Addendum Report

Planning Sub Committee - 6 March 2023

UPDATE FOR CONSIDERATION AT PLANNING SUB-COMMITTEE Item No.8

UPDATE FOR CONSIDERATION AT PLANNING SUB-COMMITTEE Item No.9

Proposed 1st floor

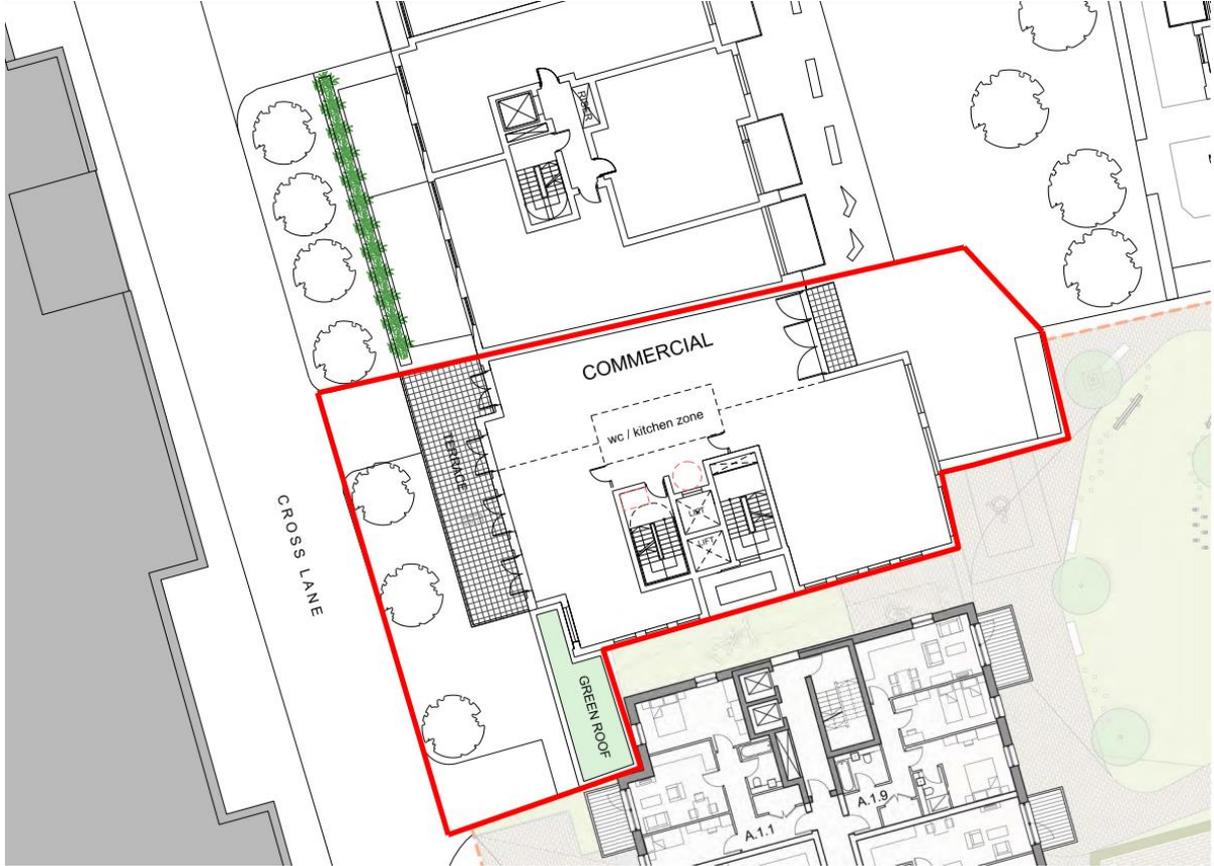
NEIGHBOURING PROPERTIES		
<p>1 further letter received</p>	<ul style="list-style-type: none"> - Disruption from the car park entrance to local residents - The first floor terrace is not set back or screened like Granita Courts terrace - Noise and disturbance from the first floor terrace in a residential area - Access to the terrace of the commercial property should be restricted - The terrace should be redesigned 	<p>The proposal will not result in any greater disruption from the car park than should be expected in an urban area.</p> <p>The 1st floor terrace would not result in a significant increase in overlooking to neighbouring properties</p> <p>The proposal will not result in any greater noise or disturbance from the first floor terrace than the current situation.</p> <p>The first floor terrace would not have a significant impact on neighbouring properties</p> <p>The design of the first floor terrace is considered appropriate</p>
